APPENDIX B

Summary of DRA Analysis of Late-Filed ALJ Exhibits

A. Estimation of hydrotest costs used to calculate disallowances for pipe replacement projects

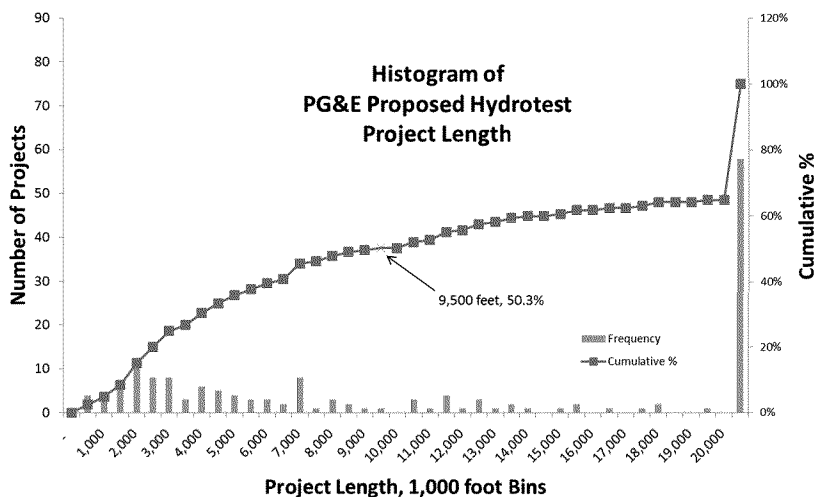
In addition, the record shows that hydrotest costs per foot decrease with increased length of a project, as fixed costs are spread over a larger length of pipe. The following chart shows hydrotest costs per foot for PG&E's 165 proposed hydrotests projects, as a function of the length of each project:

This chart shows that short test projects, including all those shorter than 10,000 feet, have a cost per foot higher than \$95.8.

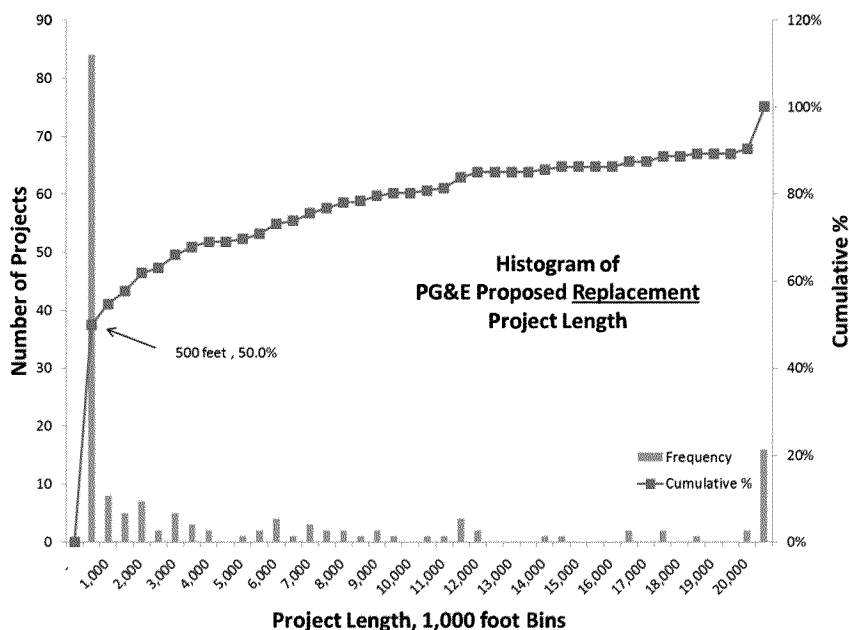
histogram of the 165 hydrotests shows the number of tests (y axis) within each project length bin (x axis):¹¹

This chart shows that approximately 2/3 of the *hydrotest* projects are longer than a mile, and 58 projects are longer than 20,000 ft. These long projects, which have a low cost per foot as shown above, drive the average cost per foot used in the PD.

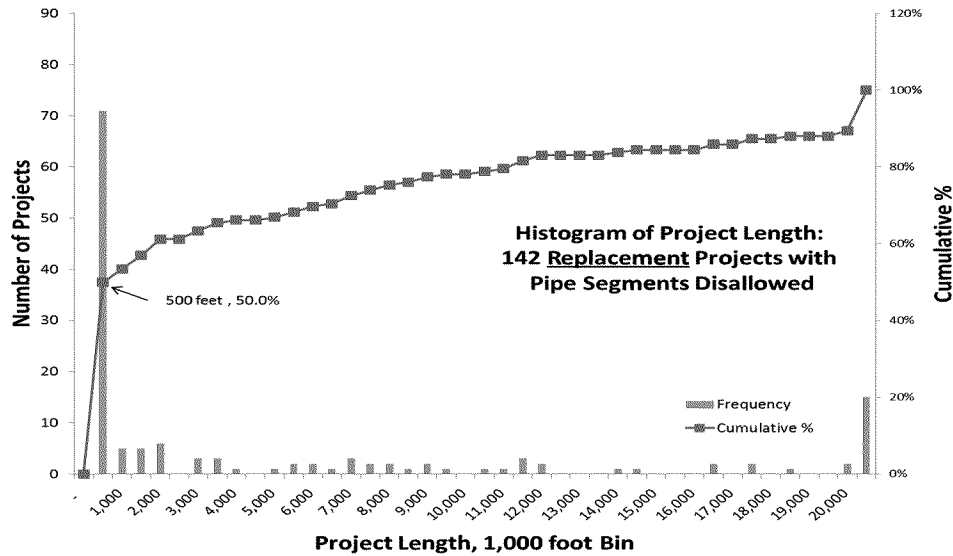
In comparison, the median length of PG&E’s proposed *replacement* projects is 509 feet, over 17 times less than the median length of *hydrotest* projects:¹²

This chart shows that the majority of proposed *replacement* tests (84 of 168) are less than 1,000 feet long.

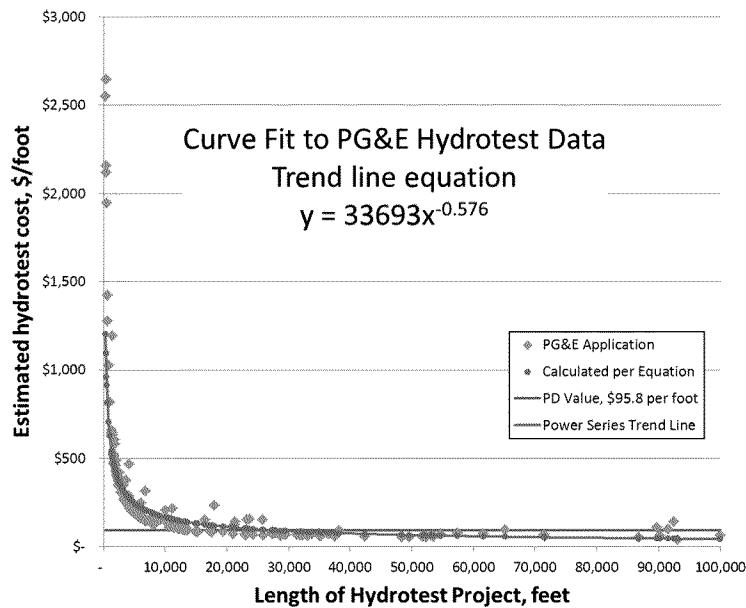
Not all replacement projects have segments that are disallowed, regardless of whether PG&E or DRA’s cost allocation criteria are used. DRA therefore performed a similar analysis on the 142 replacement projects with disallowances using the criteria of Scenario 3 as described in Section II.A.2(a) of DRA’s Comments on the PD.¹³ The median value of these projects, 512 feet, and the frequency distribution are similar to the full set of replacement projects:¹⁴

This data shows that PG&E pipe *replacement* projects are much shorter than *hydrotest* projects, and that the single estimated hydrotest cost of \$95.8 per foot is inappropriately low for use for replacement projects, the majority of which have short pipe lengths.

To calculate a more accurate estimate of pressure test costs, a curve fit was performed to determine if a simple equation could be used to estimate hydrotest cost based on project length. A standard MS Excel function yielded a power series equation that provides a reasonable fit to PG&E’s estimated hydrotest costs:¹⁵

This chart shows PG&E hydrotest cost per foot data in blue, calculated cost per foot in green generated using the equation shown, and the PD’s fixed cost of \$95.8 in red. The “Trend line equation” shown in the chart, $Y=33693 \cdot X^{-.576}$, gives the project cost per foot, “y”, as a function of the hydrotest project length, “x”. The chart shows that this equation yields a much more accurate estimate of hydrotest costs than the single figure proposed in the PD. This is particularly true for short pipe sections, which constitute the majority of PG&E’s proposed replacement projects as described above. It should also be noted that even this more accurate estimation method underestimates the cost per foot of the shortest hydrotest projects.¹⁶
